Delegated Report

Approval of Details Application

Application no:	20260135
Location:	49 St James Avenue Gravesend Kent DA11 0EZ
Description:	Application for the approval of condition 3 (Gas Impermeable Membrane) attached to planning reference number 20250893.
Applicant:	Mr N Bhadare
Site Visit Date:	N/A

Gas Membrane Installation Details

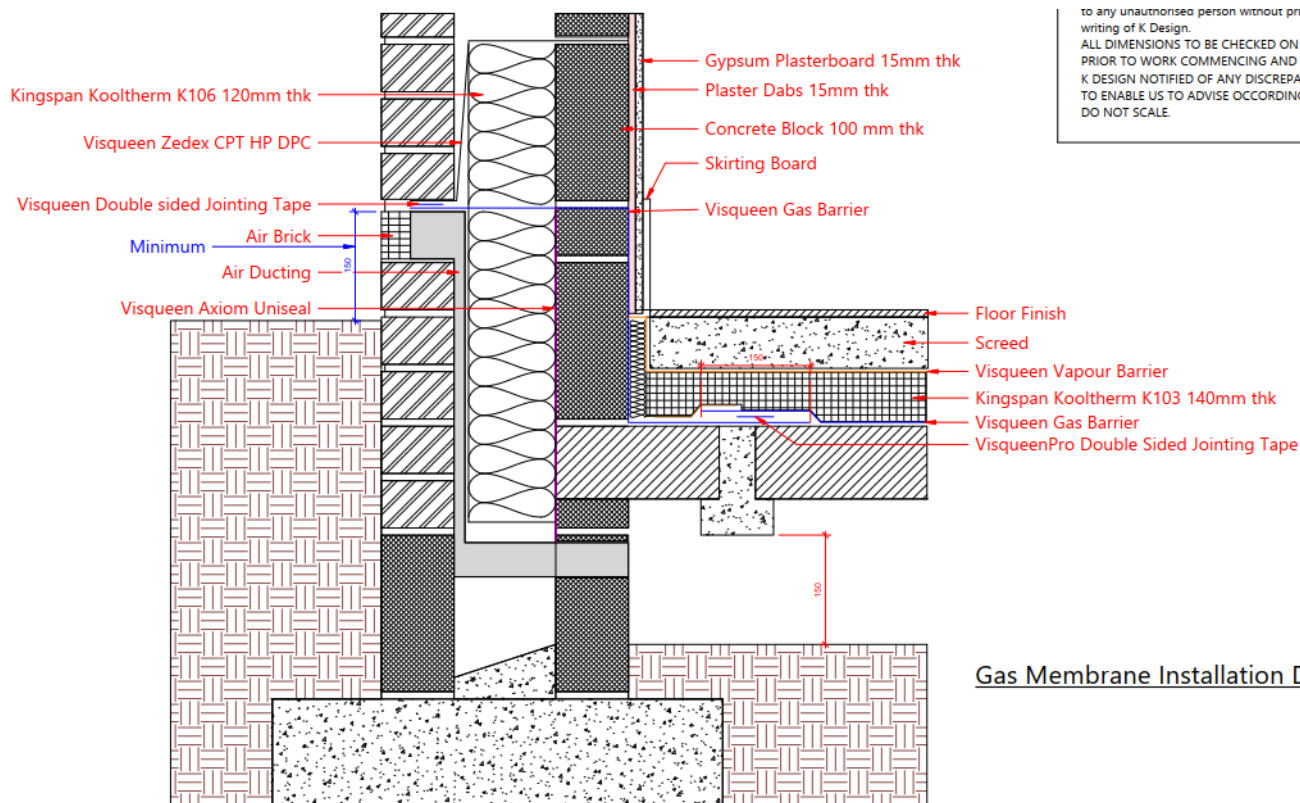
The submitted information provides a Gas Membrane Installation Diagram and technical details of the gas membrane.

This shows that the gas membrane would be as follows:

From the bottom up, it would have the various Visqueen product elements of double sided jointing tape, the gas barrier, Kooltherm (which is floor insulation), a vapour barrier, screed and then the floor finish. GBC Environmental Protection have been consulted and they have advised that the drawing and technical details which have been submitted are acceptable and that they have no objections to condition 3 being discharged.

It is considered that sufficient information has been submitted to discharge condition no. 3 of planning permission reference number 20250893.
